ACRS - 1727

MINUTES OF THE
ACRS SUBCOMMITTEE MEETING ON
EMERGENCY CORE COOLING SYSTEMS
MARCH 25, 1980
WASHINGTON, DC

NRC STAFF'S REVIEW OF WESTINGHOUSE UHI SMALL BREAK LOCA CALCULATIONS (WCAP-9639) -
MR. HOLAHAN

Figure 1 WFLASH Model for a Westinghouse PWR Upper Head Injection

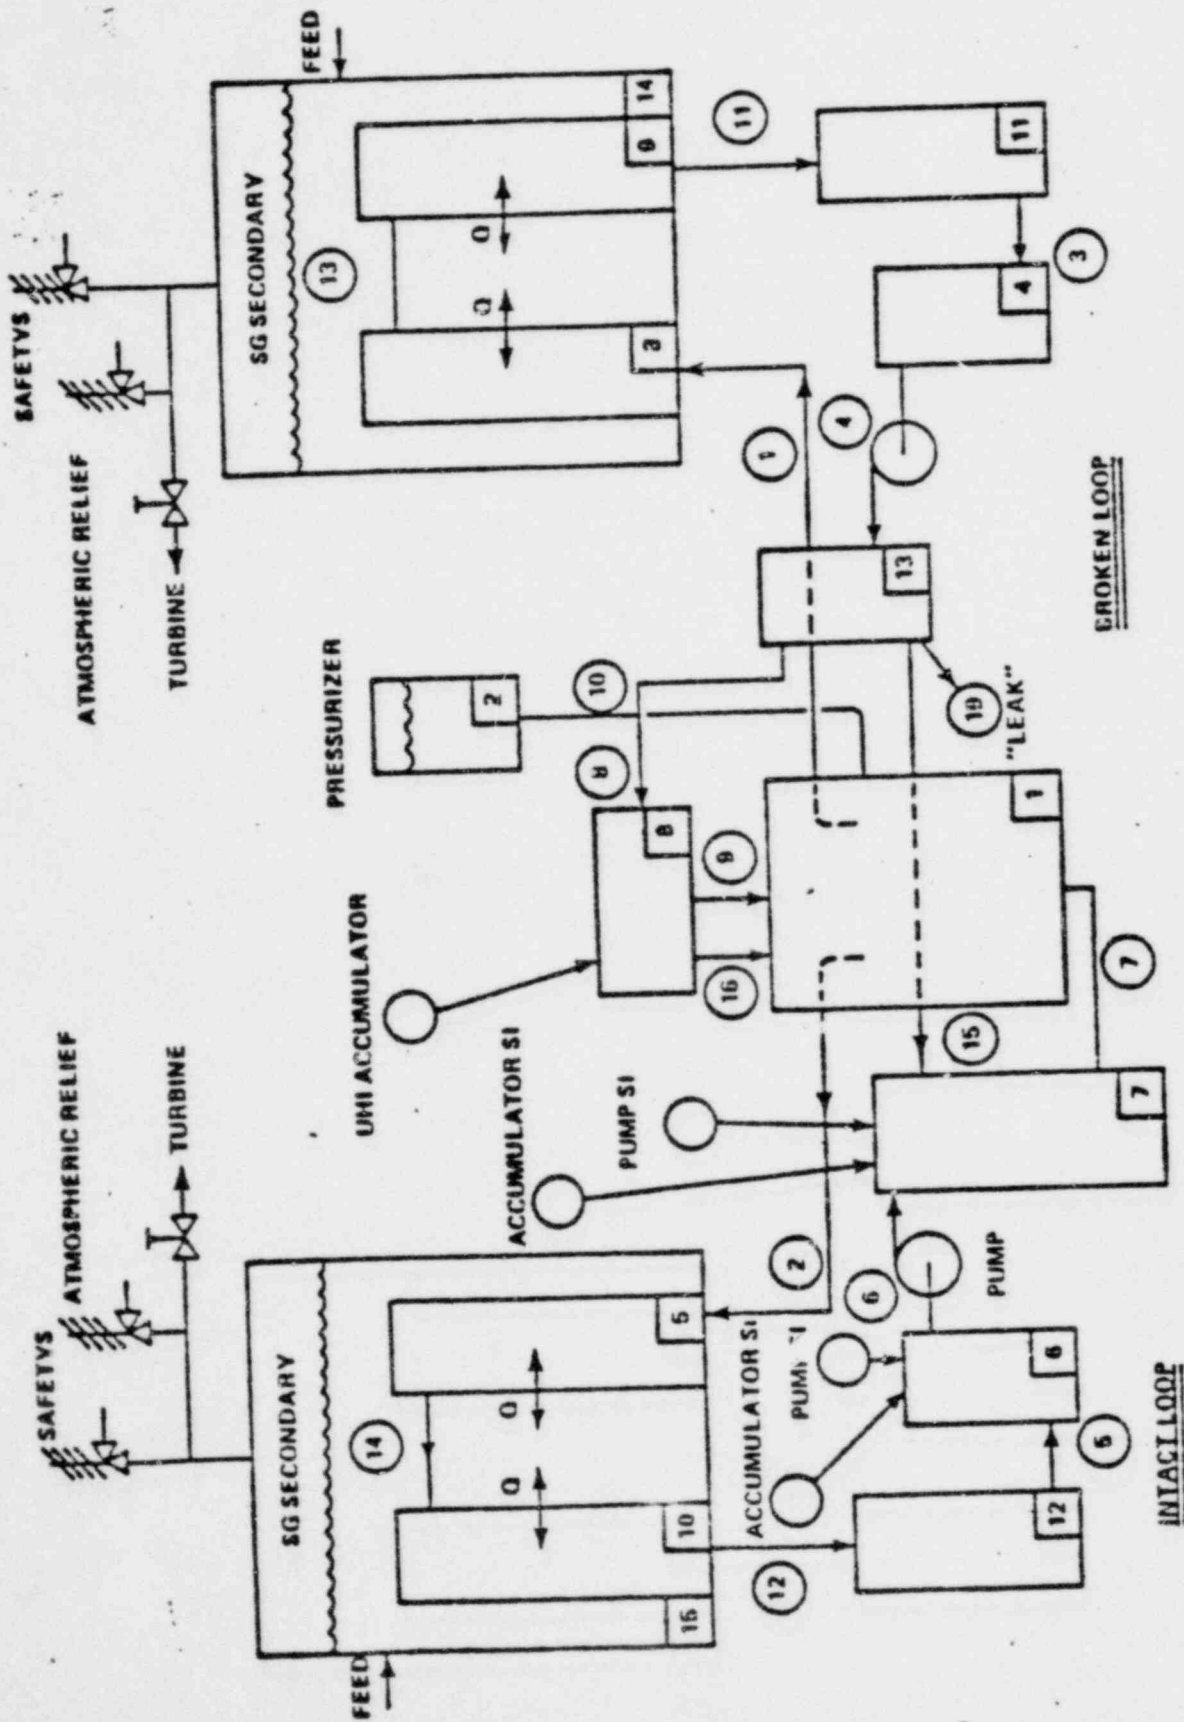
Indicating that dumping a large amount of cold water through UHI system on top of a partially voided core might lead to a 3-Dimensional motion in the core, Dr. Catton asked for justification of using 1-Dimensional drift flux modeling in the small break transient calculations.

In response to a question from Dr. Plesset, Dr. Docherty stated that the WFLASH model used in the analysis assumes that the water in the upper plenum will fall down very quickly into the periphery of the core.

Dr. Plesset commented that this does not seem to be a refined and improved model. He does not believe that this type of modeling will provide meaningful and adequate information to assess the accident situation.

In response to a question from Dr. Schrock, Dr. Docherty stated that the superficial steam velocity is calculated at the top of the core where the active fuel starts. The steam flows up the core out into the upper plenum. Along the steam flow path there may be some changes in the cross-sectional flow area; however, the total flow area tends to remain constant. Therefore, the steam velocity would not change significantly as the steam travels through the upper core plate and through the holes in the support columns and through the guide tubes.
